STAFF REPORT

APPLICATION CSP 2010-LE-013

PROPOSAL: To approve a Comprehensive Sign Plan for a hotel.

CSP APPLICATION FOR HOMWOOD SUITES HOTEL

Scale: 3/16" = 1'
Building-mounted Double-face, Illuminated Blade Sign, w/ Panaflex Sign Face.

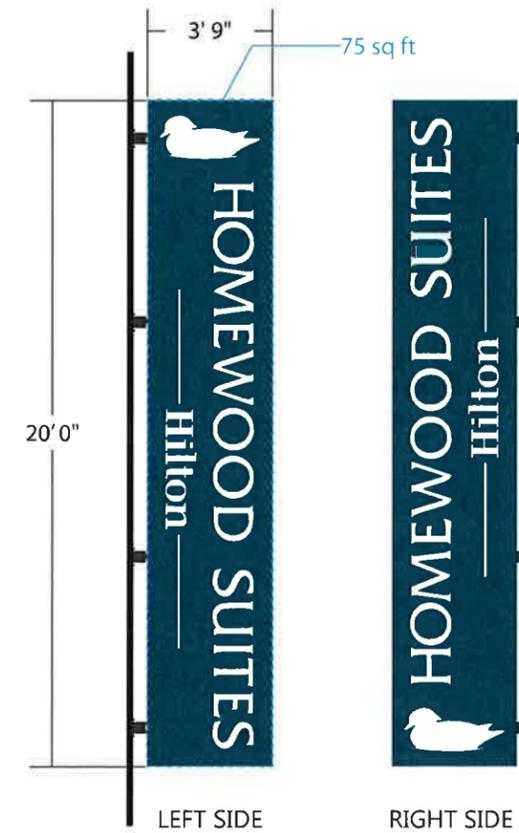
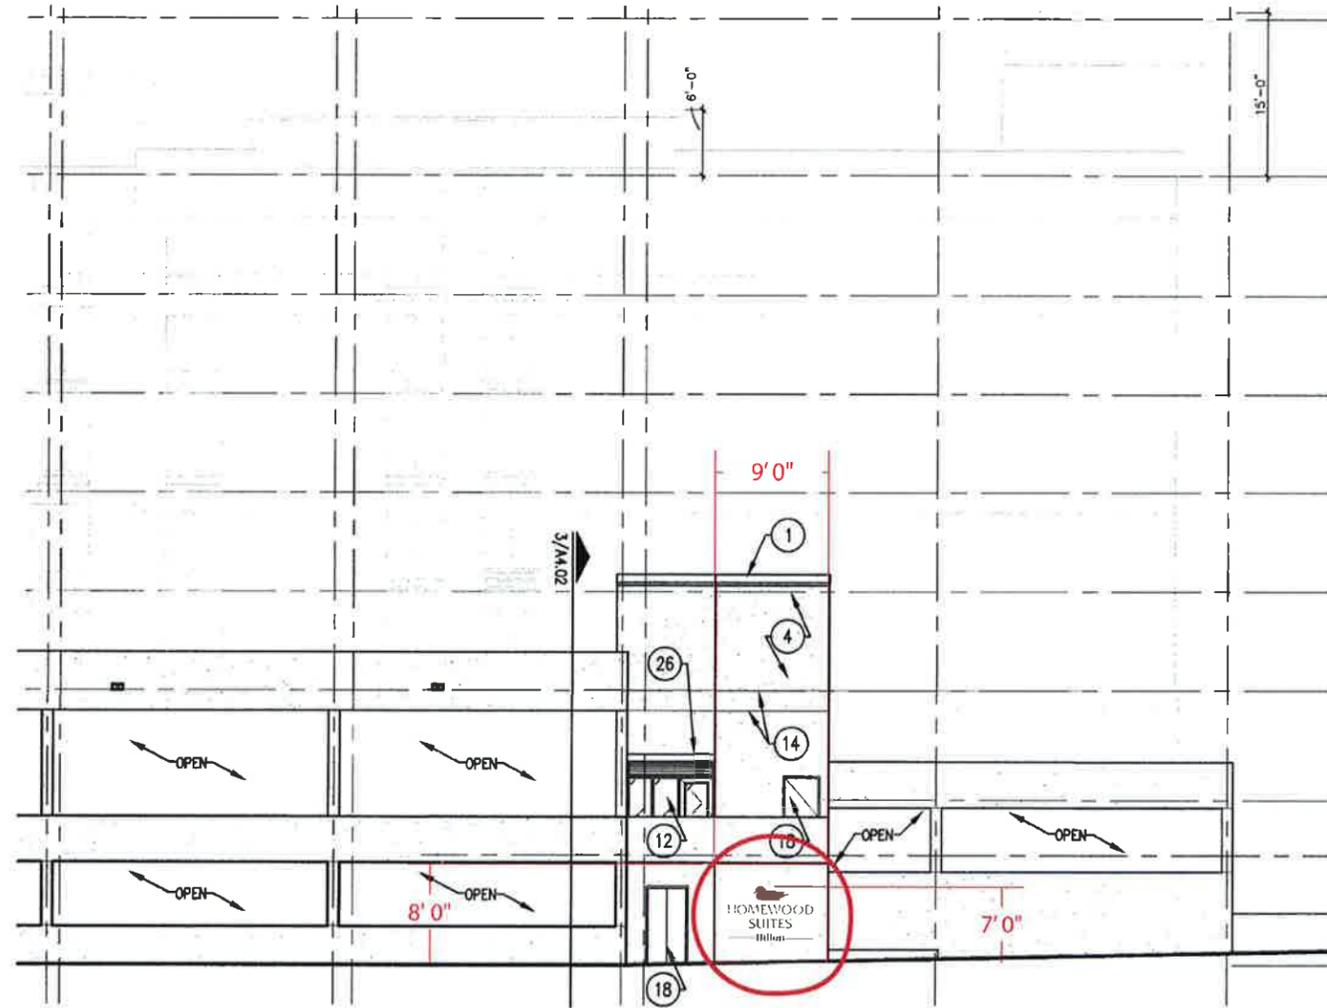
Although staff supports the applicant's choice of Sign F, the smaller blade sign, for enhanced wayfinding, the sign should be placed higher and closer to the building corner for better identification purposes. As noted in the Office of Community Revitalization's analysis (Appendix 5), the applicant should increase this sign's height on the southern façade to meet the Zoning Ordinance's minimum height of 10 feet for signs such as these that are located above a walkway. The sign should also be moved to the west so that it is closer to the building corner and above the landscaping that is planted at the building corner. This placement can also serve pedestrians along Old Keene Mill Road, directing them to the hotel's primary entrance. By placing the sign on the building as far west as possible, the applicant can satisfy these concerns while preventing the landscaping from hiding the sign. Figure 5 demonstrates the recommended placement of Sign F. Staff has included a development condition that gives the applicant the flexibility to move the sign to the staff preferred location, and to ensure that the landscaping is maintained to not obstruct the sign's view.

- The bottom of the building-mounted pedestrian blade sign is shown at 7'-0" above grade. The Zoning Ordinance (12-203) requires this type of sign to be mounted at a minimum of 10'-0" above grade.
- The sign should be moved closer to where pedestrians will turn the corner to access the lobby. This will provide more separation between the larger building-mounted banner ID sign and the pedestrian blade sign.

7. All landscaping located near Sign F shall be maintained regularly to prevent overgrowth from obstructing the visibility of the sign.
8. Notwithstanding the dimensions and location provided in the Comprehensive Sign Plan, Sign F shall be installed a minimum of 10 feet above the finished grade.

9. At the applicant's discretion, Sign F may be located at the most western point along the Old Keene Mill Road façade in an effort to provide enhanced wayfinding for both pedestrians and motorists.
